## **HUB Letter**

## **Northwest Marine Drive Cycling Conditions HUB Vancouver/UBC Committee**

May 2013

Image 1

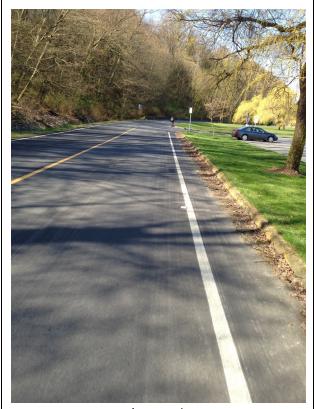
During the recent \$595,000 road upgrade project<sup>3</sup> no upgrades were made to cycling (or pedestrian) infrastructure, with the exception of improving overall road drainage. Moreover, raised reflectors were placed on the path where cyclists ride<sup>4</sup>, resulting in a substantial safety hazard: as cyclists reach increased speeds on the downhill section of the road, reflectors are sometimes obscured by debris, causing the potential for serious accidents.

We understand that the addition of reflectors to this section of NW Marine drive was a trial to determine their practicality. As reflectors create a serious hazard to cyclists, especially on roads with sub-standard shoulder width, we ask that MOTI remove the raised reflectors from the sides of the road. We further request that these type of reflectors not be used on any road which has sub-standard shoulder width.
